**Work Order ID 94349**

Item Name: Crosstube Turning Detail

DRAWING NO. D212-664-247  
TITLE CROSSTUBE (205/212 LOW AFT)

DRAWING NO. D212-664-247	TITLE CROSSTUBE ASS'Y (205 LOW AFT)	REV. B	<b>DART AEROSPACE LTD ENGINEERING ORDER</b>		D.E.O. NO. D212-664-247-B-1	SHEET NO. SHEET 1 OF 1	SCALE NTS
DRAWN 97	CHECKED ASS	MFG. APPR. [Signature]	APPROVED [Signature]		DE APPR. [Signature]		
DATE 11.07.15	DATE 11.07.20	DATE 11.07.21	DATE 11/07/21		DATE 11.07.21

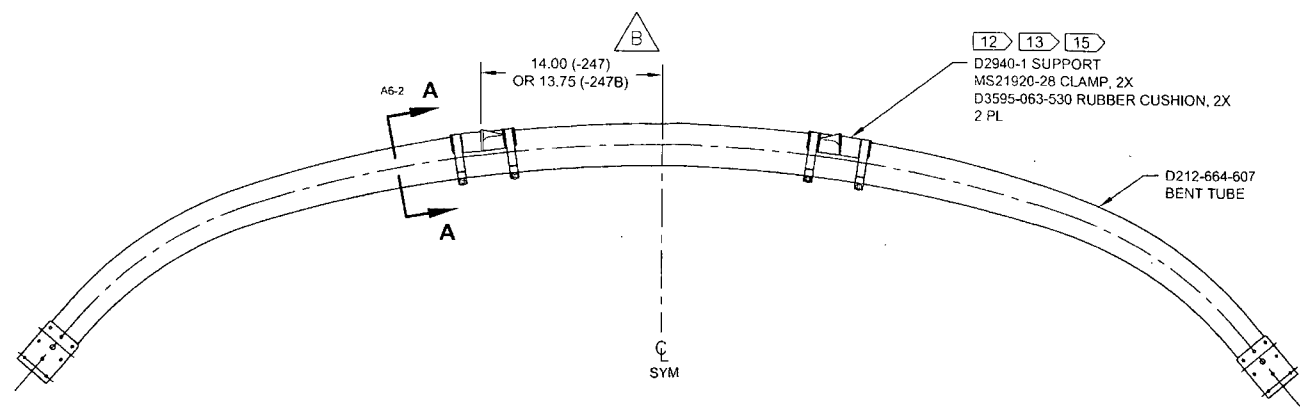
**PURPOSE:**

REPLACE MAGNOBOND WITH PROSEAL.

IS:

Item	Qty -247	Qty -247B	Part Number	Description
9	A/R	A/R	PROSEAL 890 B-2	SEALANT, AMS-S-8802 CLASS B-2

WAS:

9	A/R	A/R	MAGNOBOND 6398	ROCKWELL SPECIFICATION RBO-120-023 ADHESIVE (TEXTRON/BELL SPEC. 299-947-100, TYPE II, CLASS 2 ADHESIVE)
---	-----	-----	----------------	---

NOTE 12 & 15, SHEET 1 IS AMENDED AS FOLLOWS:

IS:

12) TO INSTALL D2940-1 SUPPORT: ABRABE MATING SURFACE OF SUPPORT AND CROSSTUBE WITH 180-GRIT SANDPAPER AND REMOVE RESIDUE WITH MEK (OR EQUIVALENT). APPLY A 0.04" TO 0.07" THICK LAYER OF PROSEAL 890 CLASS B-2 (OR AMS-S-8802 CLASS B-2) SEALANT TO MATING SURFACE OF SUPPORT.

15) TORQUE CLAMPS 80 TO 100 IN-LB. ENSURE AT LEAST 1.5 THREADS SHOWING IN SAFETY AND THAT NUT HAS NOT BOTTOMED-OUT AFTER TORQUING. **PRIOR TO PACKAGING, RE-CHECK TORQUE ON CLAMPS AFTER PROSEAL 890 SEALANT HAS CURED FOR 72 HOURS.**

WAS:

12) INSTALL D2940-1 SUPPORT USING 0.03" TO 0.06" THICK LAYER OF MAGNOBOND 6398 TO THE SURFACE OF D2940-1 THAT WILL BE IN CONTACT WITH THE CROSSTUBE PER QSI 015. LET CURE FOR 12 HOURS AFTER INSTALLATION AND PRIOR TO PACKAGING.

15) TORQUE CLAMPS 80 TO 100 IN-LB. ENSURE AT LEAST 1.5 THREADS SHOWING IN SAFETY AND THAT NUT HAS NOT BOTTOMED-OUT AFTER TORQUING.
